From: Pederson Ronda M (AREVA NP INC) [Ronda.Pederson@areva.com]
Sent: Friday, May 29, 2009 9:49 PM
To: Getachew Tesfaye
Cc: BENNETT Kathy A (OFR) (AREVA NP INC); DELANO Karen V (AREVA NP INC); VAN NOY Mark (EXT)
Subject: Response to U.S. EPR Design Certification Application RAI No. 155, Supplement 3
Attachments: RAI 155 Supplement 3 Response US EPR DC.pdf

Subject: Response to U.S. EPR Design Certification Application RAI No. 155, Supplement 2 (part 4 of 4)

QUESTIONS for Structural Engineering Branch 2 (ESBWR/ABWR Projects) (SEB2)

Figure 03.08.01-10-1—ANSYS Finite Element Model of Containment (2 Degree Slice) with Axisymmetric Boundary Conditions and Internal Pressure (red arrows)

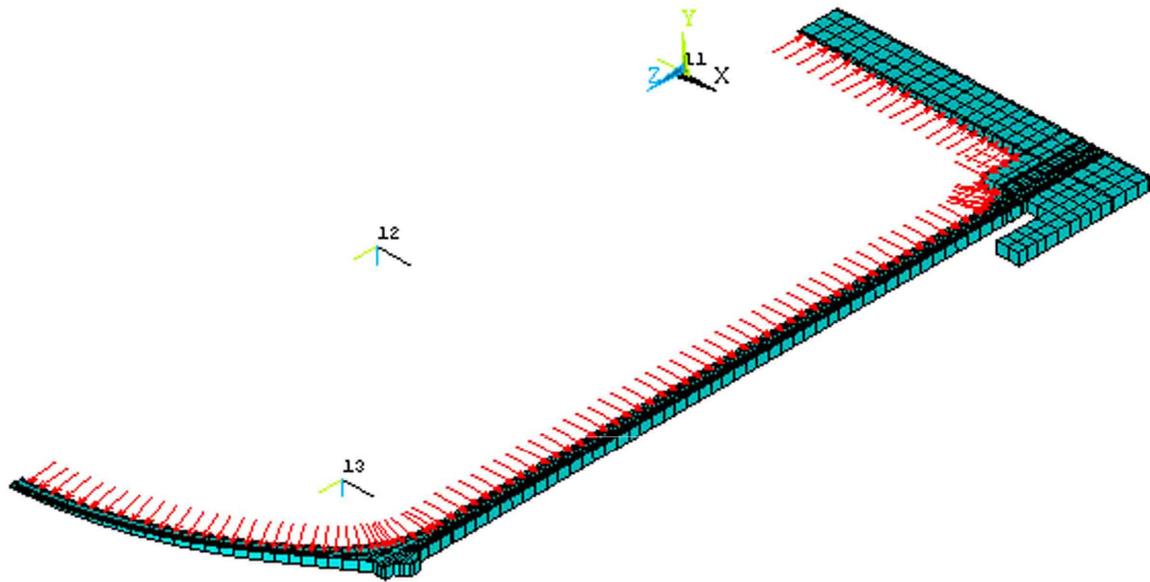
2. FSAR Section 3.8.1.4.11 indicates that the pressure capacity for various structural elements were based on the median pressure capacity. As discussed under item 1 above, the containment ultimate pressure capacity should not be determined on a probabilistic basis. Provide the containment ultimate pressure capacity for the various containment elements on a deterministic basis in accordance with SRP 3.8.1.II.4.K, or provide the technical basis for alternative criteria.

3. To support the results presented in FSAR Table 3.8-6, provide a description (including figures) which summarize and show: the models, material properties and material modeling, computer codes, loading sequences, tendon relaxation effects, concrete shrinkage & creep, potential failure modes, assumptions, and results.

displacement option turned on in ANSYS. The finite element mesh is shown in Figure 03.08.01-10-1.

**Figure 03.08.01-22-1—Location of the Selected Sectors in Containment
Slice Model**

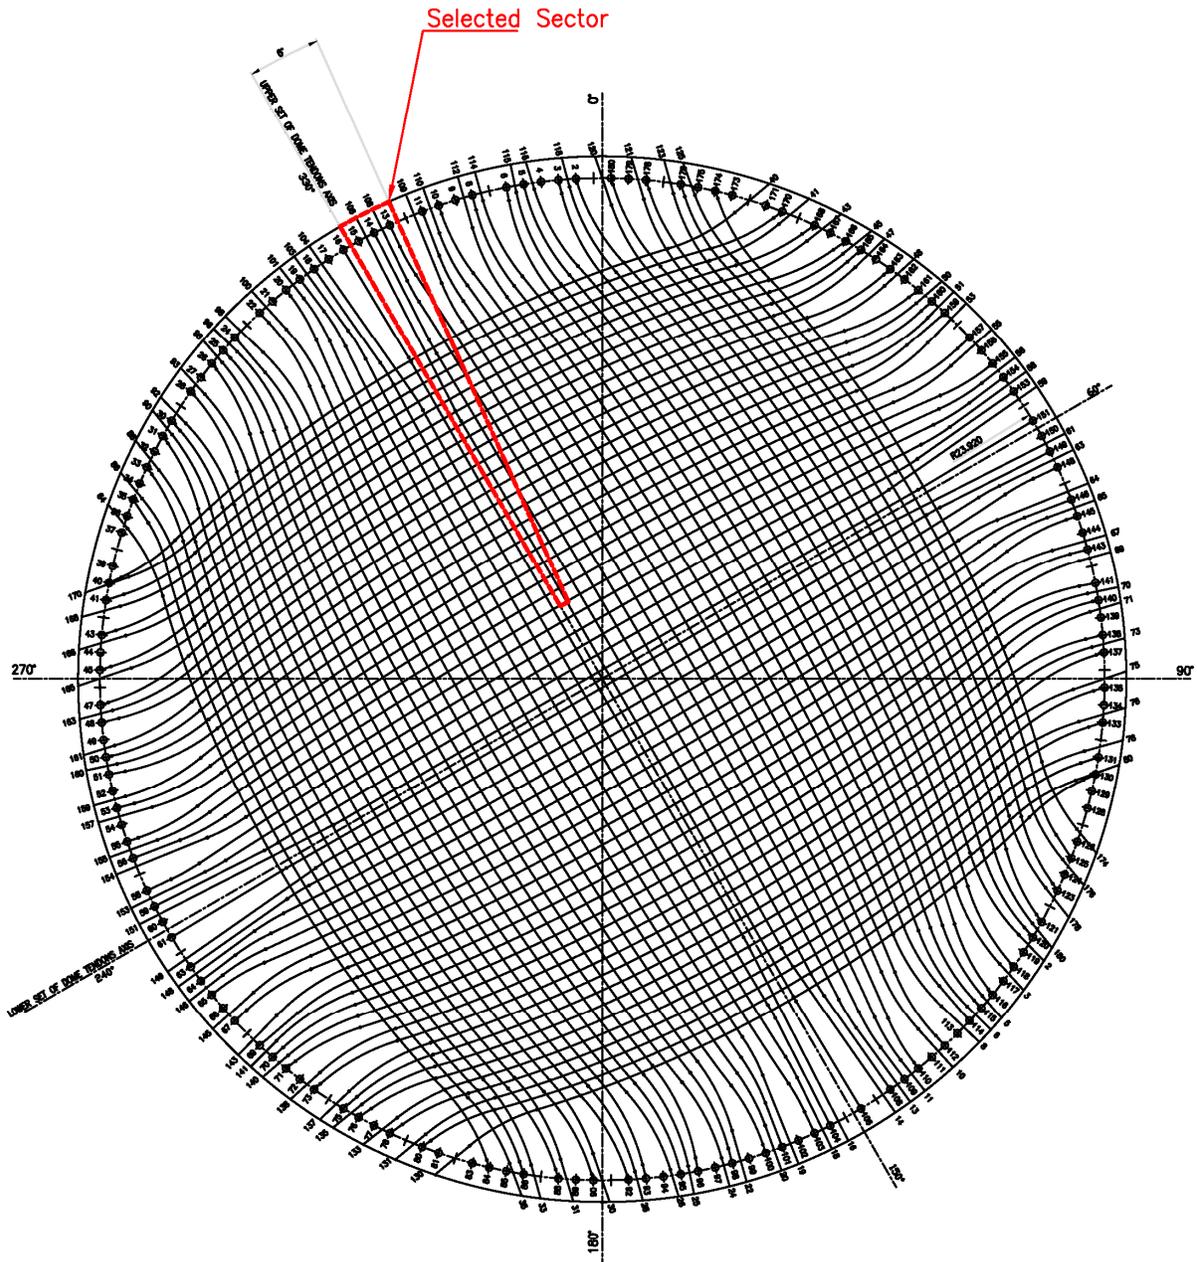
FSAR Section 3E.1.1 and other sections of Appendix E state that a separate analysis was performed to estimate the effects of cracked concrete and based on the results of the analysis the thermal moments carried by portions of the RCB were reduced. Describe the analysis performed including a description of computer codes, identify other concurrent loads that were considered in the analysis, the method used for reducing the thermal moments, how the final design loads were determined, and identify the portions of the RCB where this was done. Provide a similar description for the treatment of thermal moments in FSAR section 3.8.3, 3.8.4, and 3.8.5. Include in this discussion under what conditions these moments were considered and where in each structure thermal moments were reduced.

- A typical sector of the containment away from the discontinuities is identified and shown in Figure 03.08.01-22-1. A 6° slice of the containment is selected for study.

Figure 03.08.02-6-1—Medium Voltage Electrical Penetration

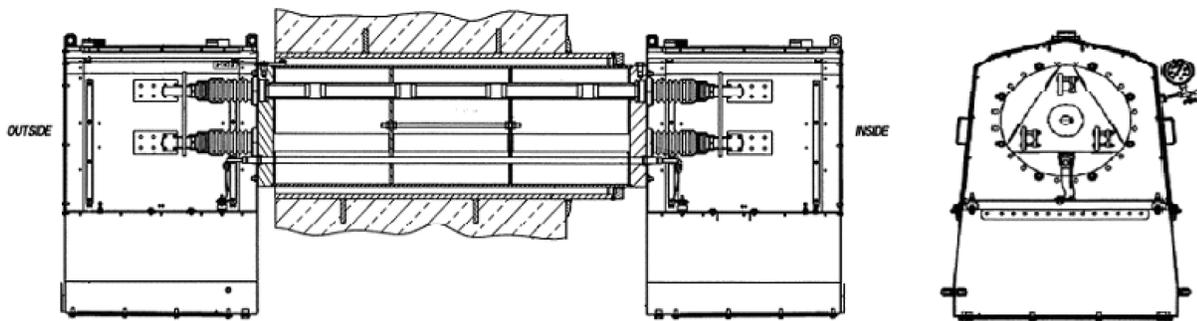
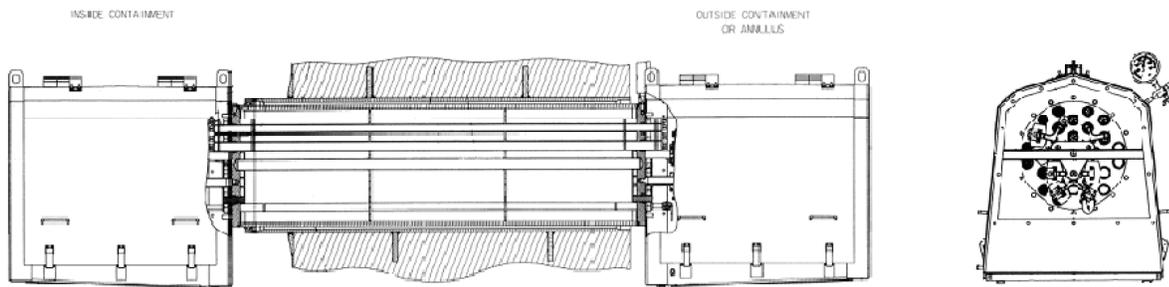
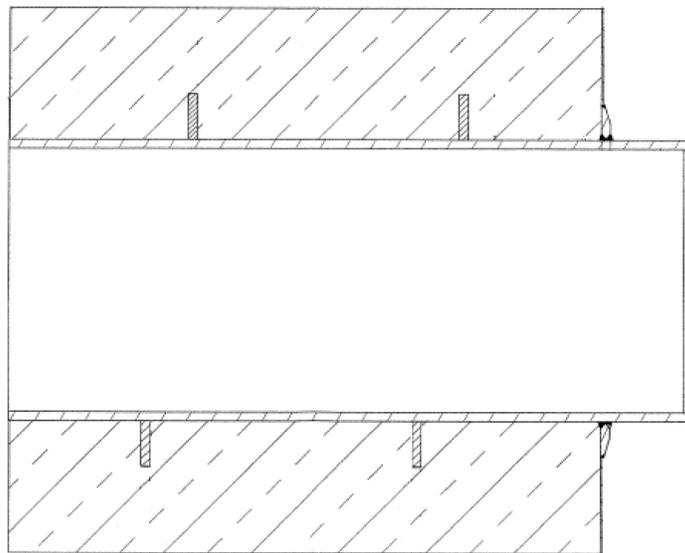
GDC 16 requires that reactor containment and associated systems shall be provided to establish an essentially leak tight barrier against the uncontrolled release of radioactivity. FSAR Section 3.8.2.1.3 discusses electrical penetrations through the containment boundary. What qualification and testing will be done, or has been done, to assure that electrical penetrations will meet the requirements of GDC 16 and will withstand the pressure and temperature conditions under the design basis accident? Provide details of the electrical penetrations including any spares.

Figure 03.08.03-11-1—Boundary Between Containment Structure and Crane Assembly

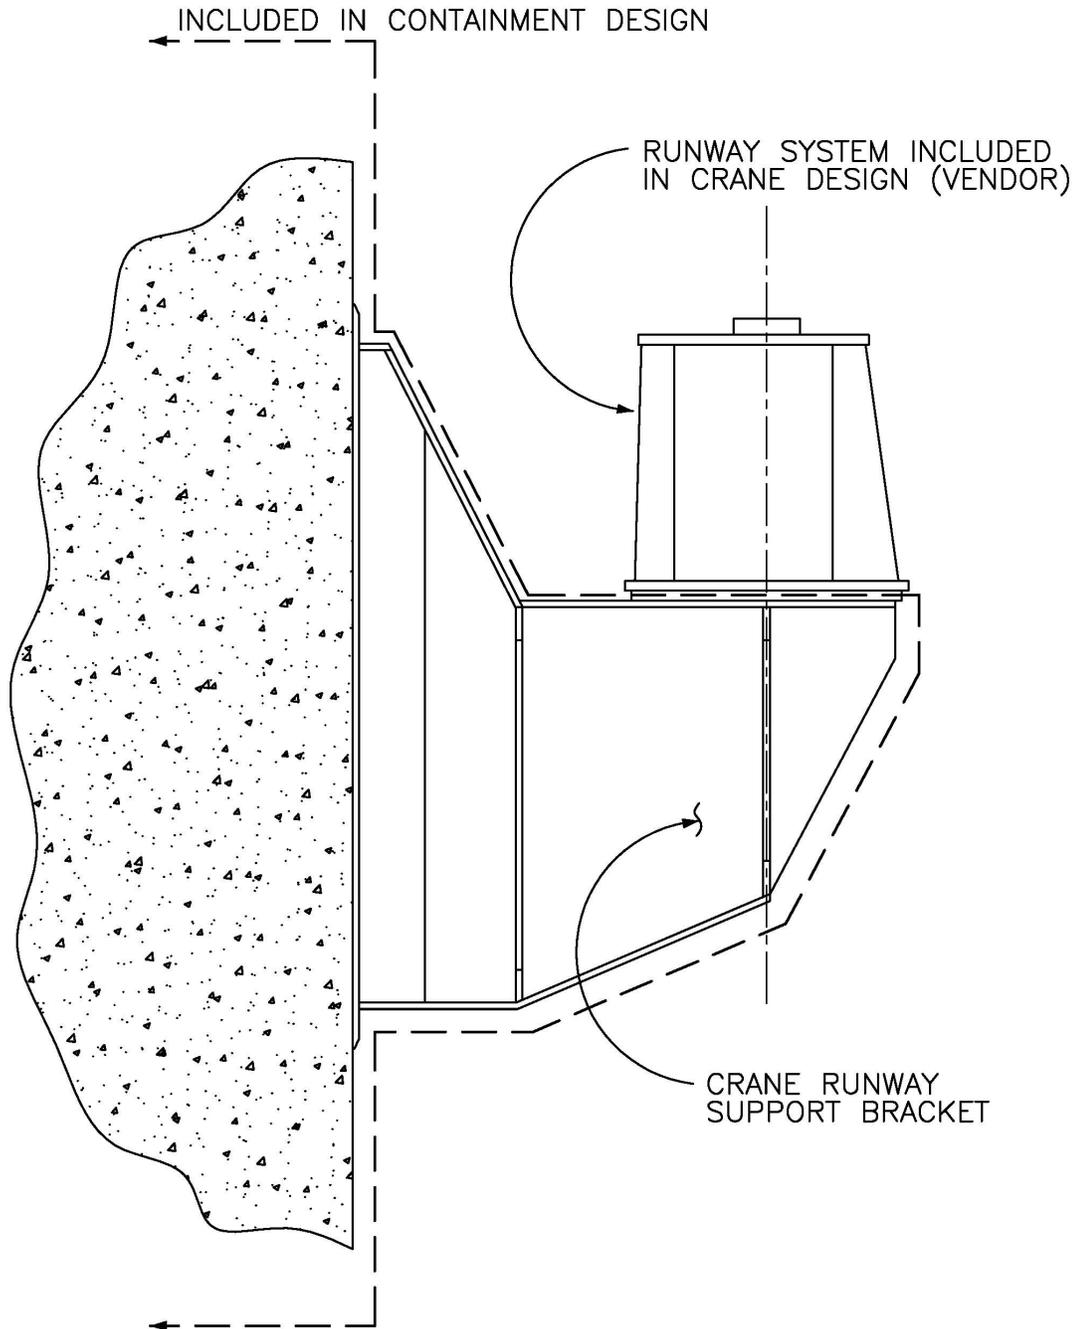
1. Explain what structural members are considered to be within the scope of containment internal structures. Provide a detail showing the boundary of these structural members and the crane assembly, and the jurisdictional boundary between these structural members and the RCB.
2. Describe the analysis methods including computer codes that were used to analyze and design these intervening structural members between the polar crane assembly and the RCB wall.
3. Provide the materials and design codes that were used for the crane girder and the intervening structural members.

1. The polar crane support brackets (steel) are included in the design of the containment vessel. The boundary between the brackets and the crane is the location at which the crane runway support system (girders) attaches to the brackets. A detail showing this interface (boundary) is provided in Figure 03.08.03-11-1.
